**Re: Loreto Normanhurst – Early Learning Centre (ELC)
Response to Deferral Decision; Traffic and Transport**

Independent Road Safety Audits

Existing stage road safety audit

Figure 1: Peak Queuing Observed on Osborn Road

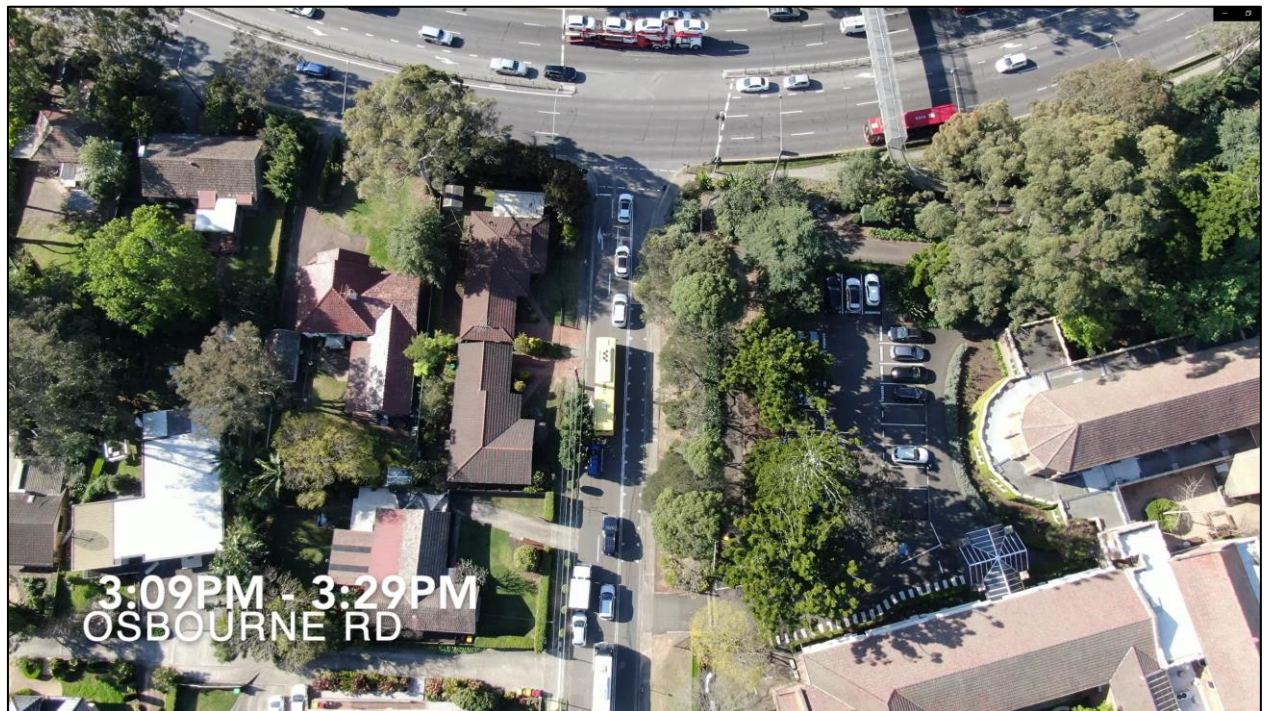
The drone surveys demonstrated only minor queueing in both the AM and PM peak periods. Whilst some queueing was observed during the peak morning and evening pick-up times, the videos demonstrate that these queues clear under each intersection cycle. The maximum number of vehicles observed existing at any time from Osborn Road under each cycle was some 9 vehicles (Figure 1). The peak observed times were between 8:17-8:33am in the morning peak and 3:10-3:25pm in the afternoon peak. Please refer to the link above to view these.

This validates the SIDRA analysis undertaken by Ason Group, which found that the intersection was operating with a good Level of Service (LOS B), with acceptable delays and spare capacity. The potential to widen Osborn Road in the vicinity of its intersection with PHR was a suggestion raised at the Panel to create additional capacity for vehicles leaving Osborn Road (i.e. additional left / right / through lanes from Osborn Road). However, the SIDRA analysis, which has been confirmed and validated by the drone surveys, illustrates that this is not required.
